BRIDGE No. 30
PROJECT No. BHF 0283 (9) S — ITEM No: 621.745

FOR: A.D. ROSSI CORPORATION
VERMONT AGENCY OF TRANSPORTATION
TOWN OF BERKSHIRE, COUNTY OF FRANKLIN
3–LINE SEMI–ELLIP. ALUM. APPROACH RAIL FOR VT RTE 118
3L ALUMINUM APPROACH RAIL ~ MISC DETAILS

MADE CMS DATE 02/18/10 JOB No. AR0624 CUST. No.
CHECK BLJ DATE 02/25/10 DRAWING LB16(LAST) REV. No.

DETAIL "B"
(FRONT ELEVATION VIEW)

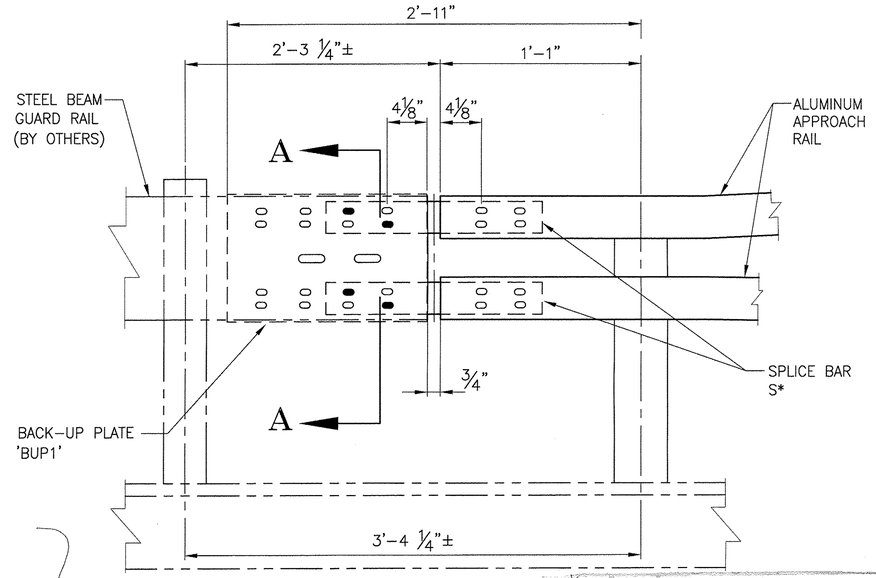
APPROVER,,
THERE APPEARS TO BE A DIMENSIONAL PROBLEM WITH THE STATE STD. DWGS ON THE SIDE AT THE RAIL SPLICE. THE 4 5/8" WOULD EXTEND THE PLATE BEYOND THE CENTERLINE OF THE SPLICE TOWARDS THE RAILING.
PLEASE VERIFY.

Agreed.
